# **FIRE SAFETY INSPECTION REPORT**

**Factory Name: Consumer Knitex Limited (Unit 2)**

**ACCORD ID: 12576**

**Date: 07 November 2016**

6 Egress

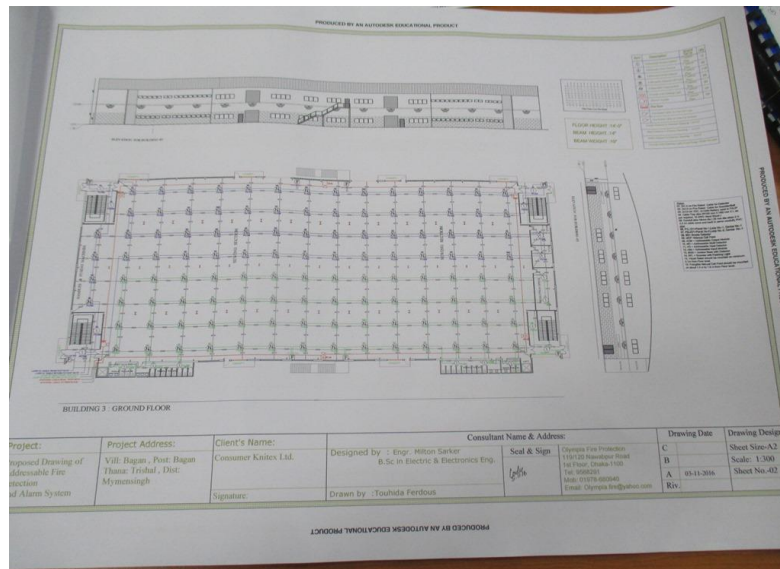
The factory is using/storing liquefied gas cylinders (C.N.G) having a pressure reduction & control unit (RCU) station on the egress path.

Provide a minimum 2-hr horizontal separation from egress path to using/storing liquefied gas cylinders & RCU station
